## REMARKS

**Amendments to the Drawings:**

FIG. 10A

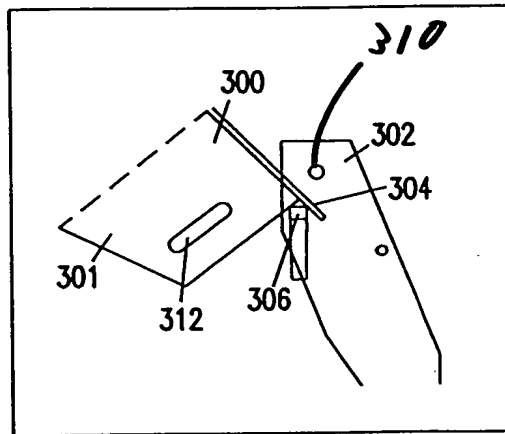
The specification is amended on page 10 to replace the reference number "46" with the corrected number "406." This amendment clearly corrects a typographical error. In addition, Figures 10A and 12A are amended to include the reference numbers "310" and "454." It is submitted that one skilled in the art would clearly understand that these changes based upon the disclosure of the above-identified patent application at, for example, page 9, lines 19-31, and page 10, line 20 through page 11, line 2.

The drawings stand objected to on the grounds that certain reference numbers are not present in the drawings. Page 10 of the specification has been amended so that reference number "46" has been replaced with reference number "406." The reference number 168 is present in Figure 6. The reference numbers 310 and 454 are now present in amended Figures 10A and 12A, respectively. Enclosed with this amendment are replacement sheets including amended Figures 10A and 12A and annotated sheets showing the changes to Figures 10A and 12A.

The attached sheets of drawings include changes to Figures 10A, 11, and 12A. These sheets, which include Figures 10A-10D, 11, and 12A-12B, replace the original sheets including Figures 10A-D, 11, and 12A-B. In Figure 10A, the previously omitted reference number 310 has been added. In Figure 11, a line has been removed. In Figure 12A, the previously omitted reference number 454 has been added.
